ENGINE - LP COMPRESSOR - REMOVAL OF THE SHARP EDGE OF THE PANEL SUPPORTING BRACKET -
CATEGORY CODE 6 - MOD.ENG-72-0246

V2500-ENG-72-0246

Location of Panel Supporting Brackets
Fig.1

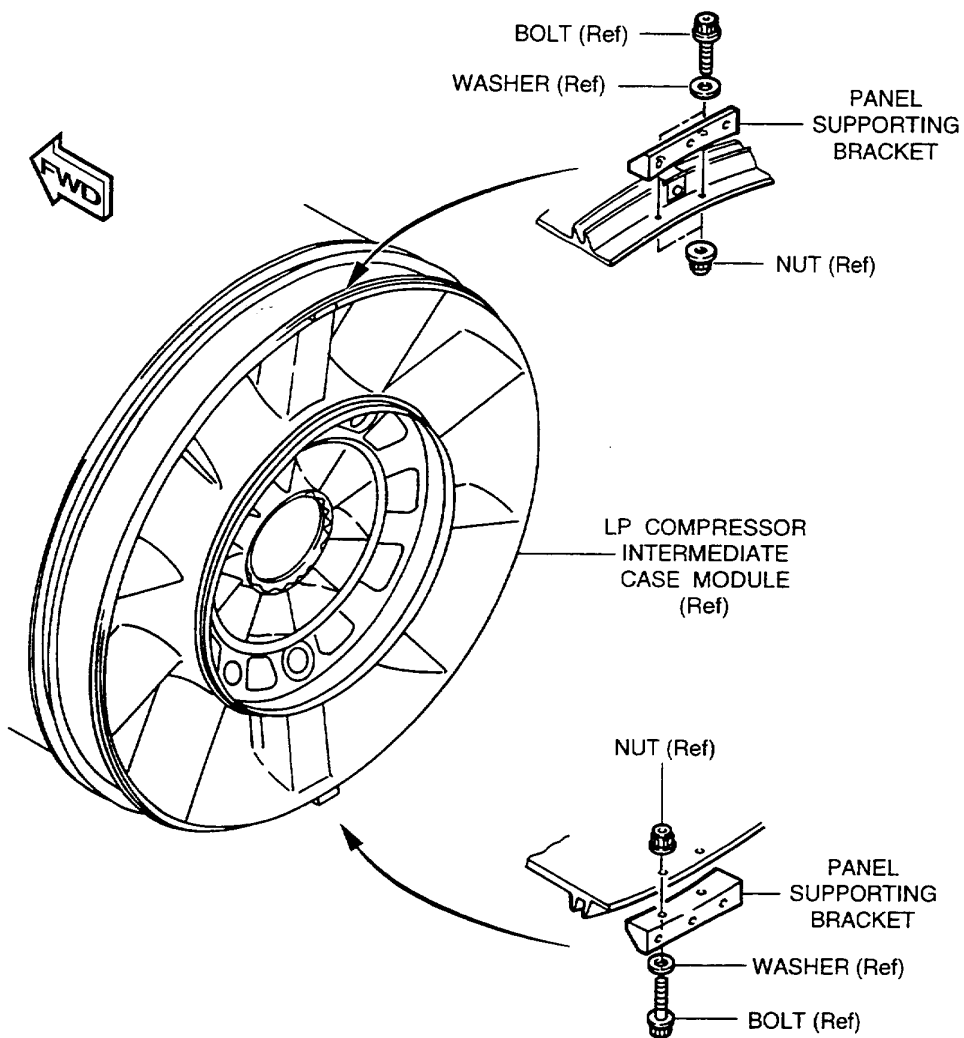
- (1) This Service Bulletin instructs to replace two existing Panel supporting Brackets with sharp edge to the new Brackets with rounded corner (See Figure 1).
- (2) Existing Panel Supporting Bracket can be reworked (See Figure 2).

Rework of Panel Supporting Brackets
Fig.2

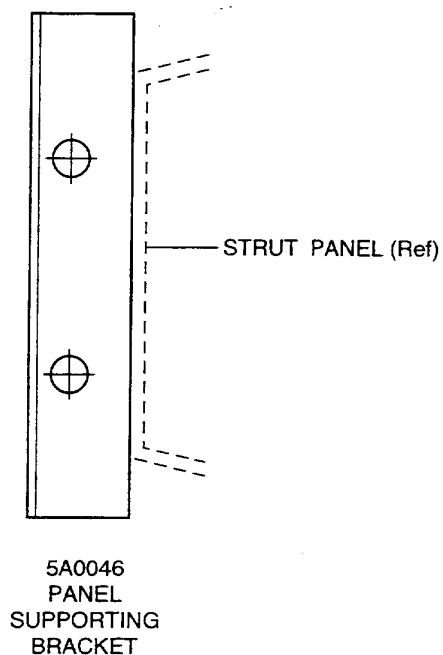
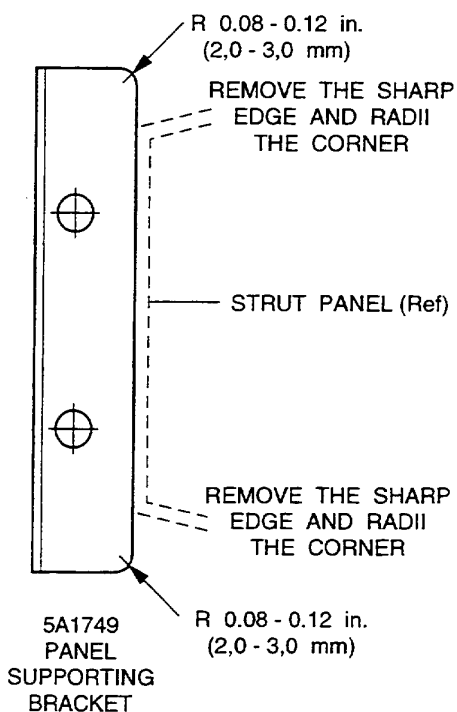
Procedure	Supplemental Information
a) Remove the sharp edge on the existing Panel Supporting Bracket and radii the corner, Radius 0.08 - 0.12 in (2,0 - 3,0 mm).	Refer to Figure 2.
d) Re-number adjacent to the existing part number and cancel the existing part number.	Existing Re-number 5A0046 5A1749 Refer to Reference (3), 70-09-00, Marking of Parts.
